INDEPENDENT DESIGN REVIEW REPORT FOR TRUCK # 1 MODIFICATIONS FOR FLAMMABLE GAS TANKS

EDT/ECN: 619143 UC: 2030
Org Code: 08E00 Charge Code: N4H2B
B&R Code: EW3120074 Total Pages: *AT 42 KMB 5/9/97*

Abstract: This document records the independent design review that was conducted for Core Sampler Truck #1 modifications to comply with standing order.

(10) Alarm Circuit ladder diagram:

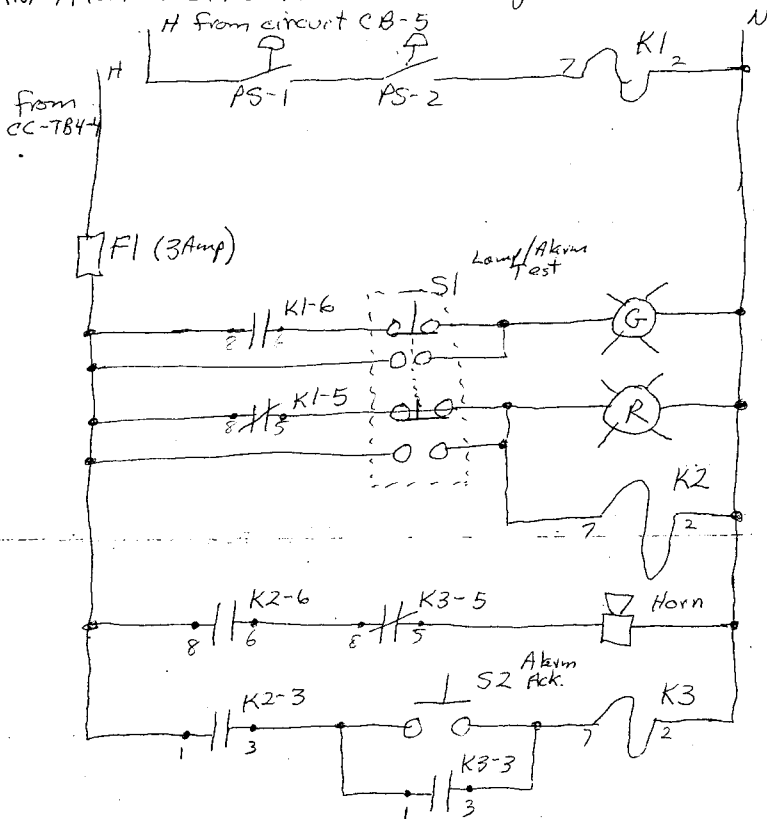
5	Items 2.1 and 2.2 of Design Matrix: Alarms not redundant. There is only one light, one horn, one relay to activate the alarm, and one power source for the alarm circuit. There is only one contact on relay K1 that actuates the alarm.	Yes	Not accepted. The draft of the Design Compliance Matrix (DCM) was in error. Redundant alarms are not required. The DCM has been corrected.

This will make existing circuit work. See explanation on next page. However, I would not consider this a redundant circuit. BRJ.

(10) Circuit function:

PS-1 and PS-2 normally closed and K1 normally energized when pressure is high. K1-6 contact closes and green light is ON. Contact K1-5 is open and red light OFF and K2 relay deenergized.

On low pressure or K1 relay power failure, K1 deenergized. Contact K1-6 opens and green light is OFF. K1-5 contact closes and Red light ON and relay K2 ~~energ~~ energizes. K2-6 contact closes and horn sounds. Contact K2-3 closes and makes ready the acknowledge circuit.

Upon pressing S2 to acknowledge alarm, K3 relay energizes and opens contact K3-5 and turns horn OFF. Contact K3-3 closes and seals in K3 relay to maintain acknowledge circuit. Upon pressure increase, K2 relay deenergizes and resets acknowledge circuit by resetting relay K3.
